25 September 2015  
F500-L15-030

**Subject: Special Technical Letter: Fuerza Aérea Mexicana (FAM)-Proposed  
Special Use Airspace**

**Figure 1. Vertical Ceiling for MMR-112**

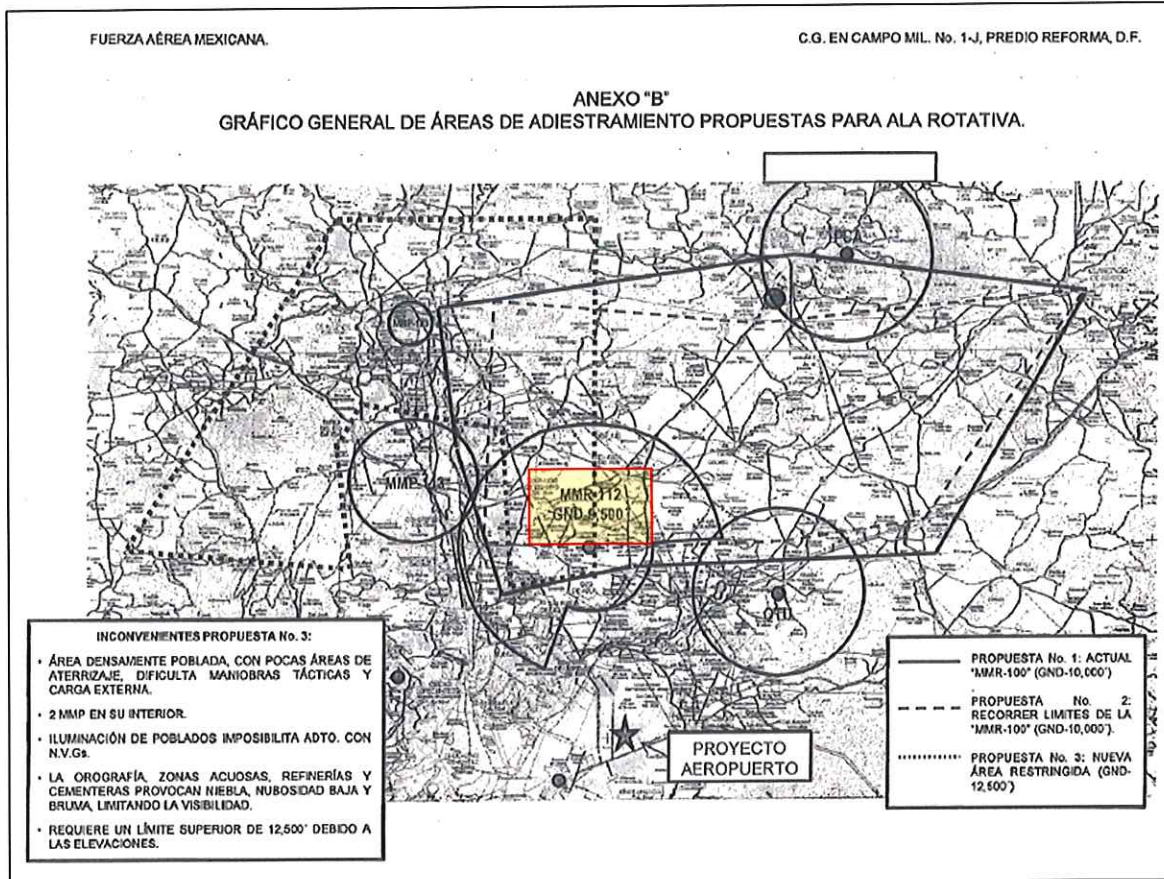
1. Page 1 of the FAM letter states that there will be training conducted at NAICM and that traffic would continue to fly to MMR-102 and MMR-103. This causes MITRE concern due to the impact on operations, efficiency, and possibly safety at NAICM. Therefore, this matter needs to be discussed further before any final decisions are made. Please clarify what types of training would be conducted at NAICM and what types of aircraft would the training involve.
2. It is not clear to MITRE what vertical ceiling is being proposed by FAM for MMR-112. For example, the FAM's proposal for MMR-112 on page 4 states that MMR-112 would continue with its present dimensions; only reducing the distance between radials 085° to 200° from 5 nautical miles to 3 nautical miles. However, on the picture in ANEXO "B" GRÁFICO GENERAL DE ÁREAS

DE ADIESTRAMIENTO PROPUESTAS PARA ALA ROTATIVA on page 7 of FAM’s proposal, the MMR-112 area is labeled as “GND 9,500”. See Figure 1 below.

Please indicate which vertical ceiling FAM is considering for MMR-112.

Figure 2. Confusion Regarding ANEXO B

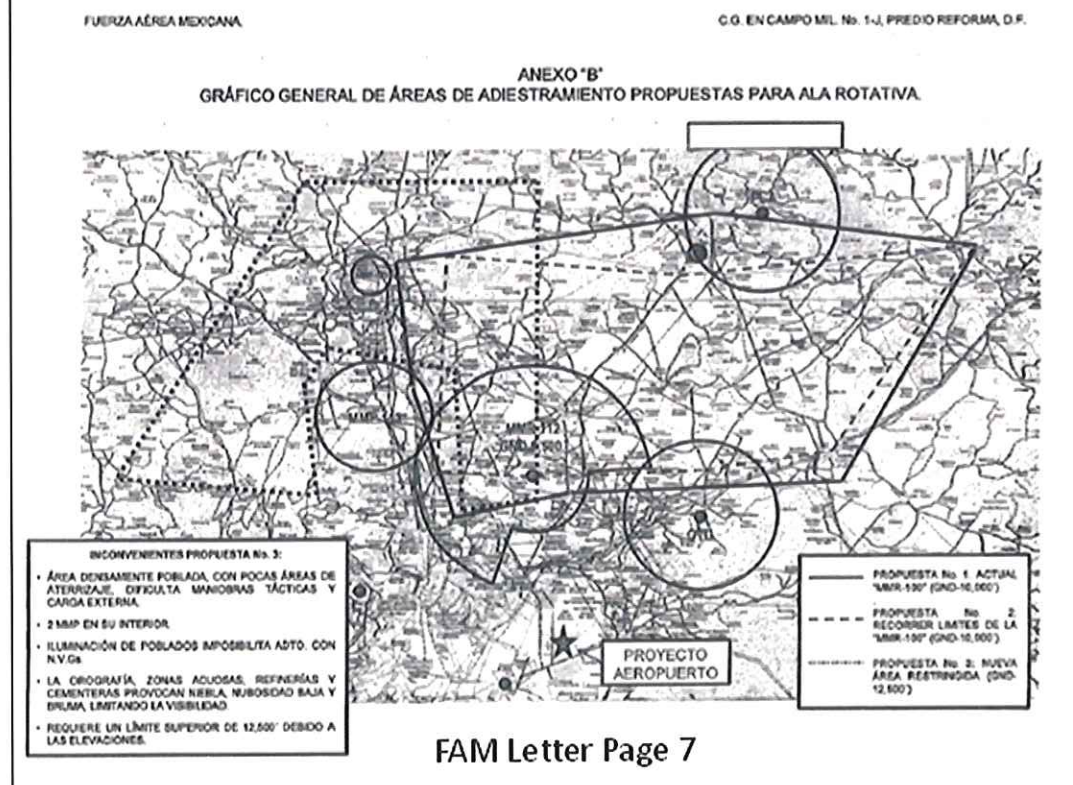
3. Please provide MITRE with the coordinates for the proposed helicopter areas numbers 2 and 3 that are depicted in ANEXO “B” on page 7 of the FAM letter.
4. What is the difference between the figures on pages 6 and 7 of the FAM letter? Note that both figures are labeled ANEXO “B” GRÁFICO GENERAL DE ÁREAS DE ADIESTRAMIENTO PROPUESTAS PARA ALA ROTATIVA. See Figure 2 below. The figures on these pages are different, but the titles are the same and it is not clear from the text what is being referred to.

**Figure 4. Incorrect Node Coordinate for MMR-100 N**

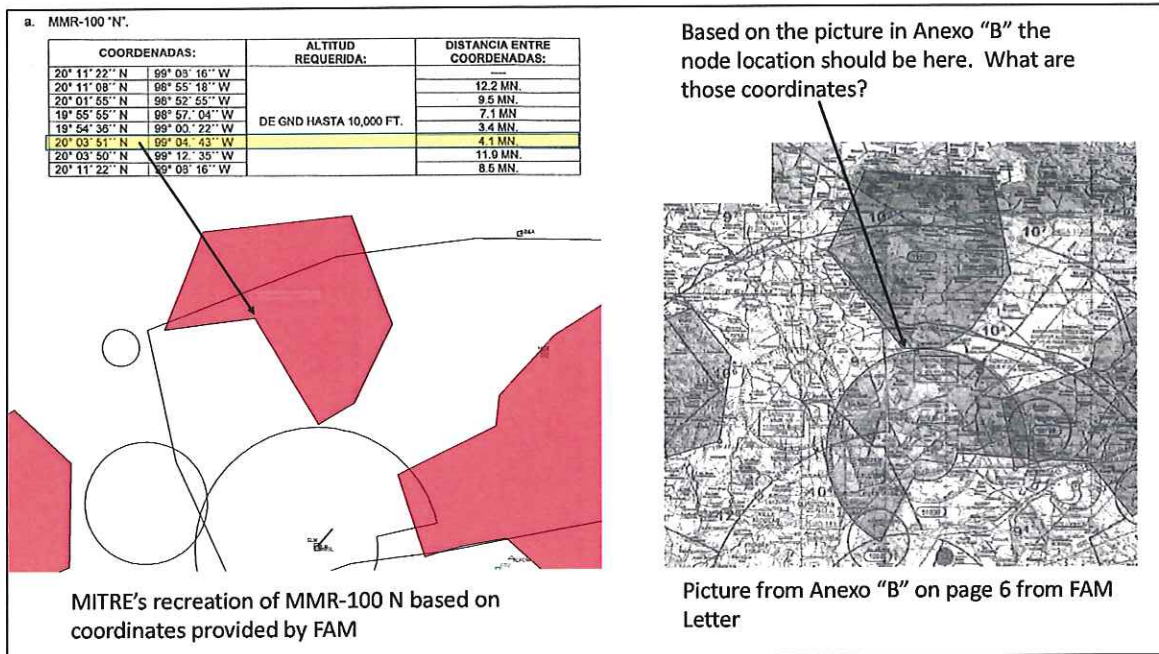
5. How often does FAM expect training area “II” to be active?
6. What is the correct latitude and longitude for the sixth node of FAM-proposed MMR-100 N? The latitude and longitude information for this node does not match what is depicted in the picture on page 6 of the FAM letter. See Figure 4 below for a more detailed explanation.
